To: T10 Technical Committee  
 From: Rob Elliott, HP (elliott@hp.com)  
 Date: 29 December 2003  
 Subject: 03-186r3r4 SAS-1.1 Transport layer retries

### **Overview**

Figure 2 — ST\_I (transport layer for SSP initiator ports) state machines

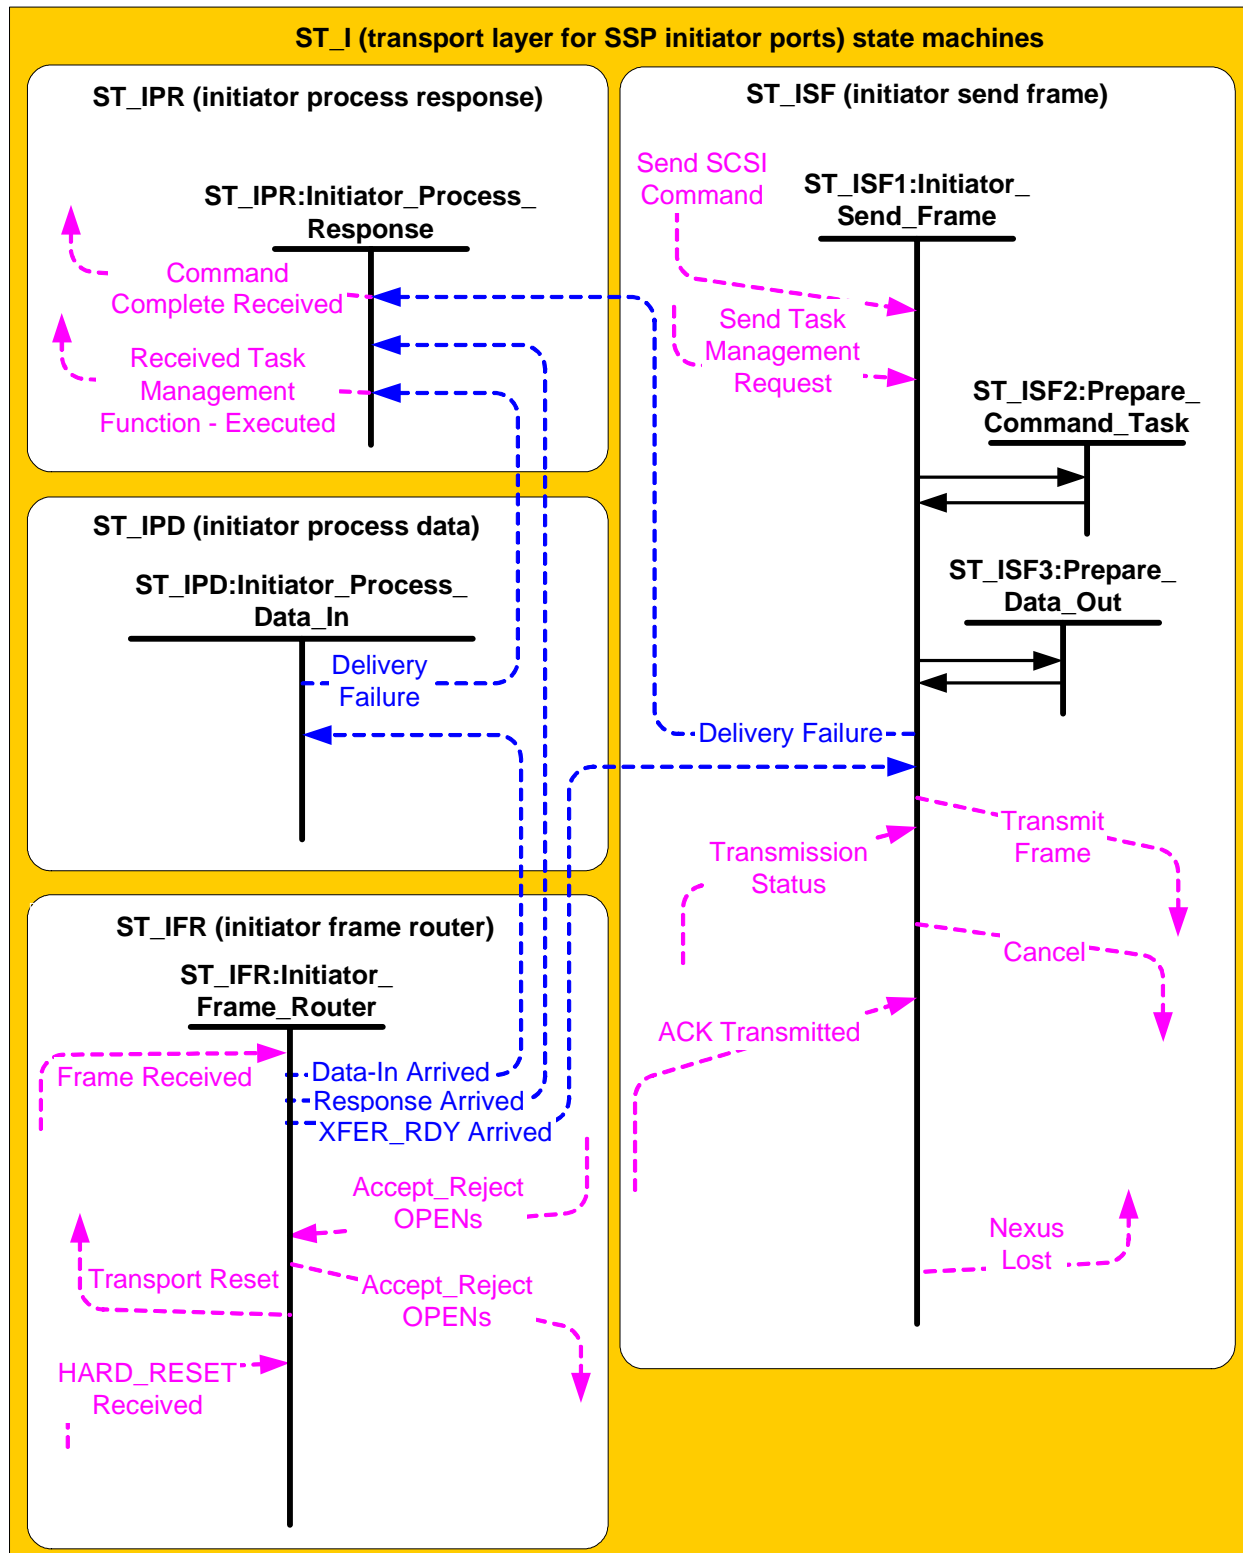
## 9.2.6 ST (transport layer for SSP ports) state machines [\[modifications throughout\]](#)
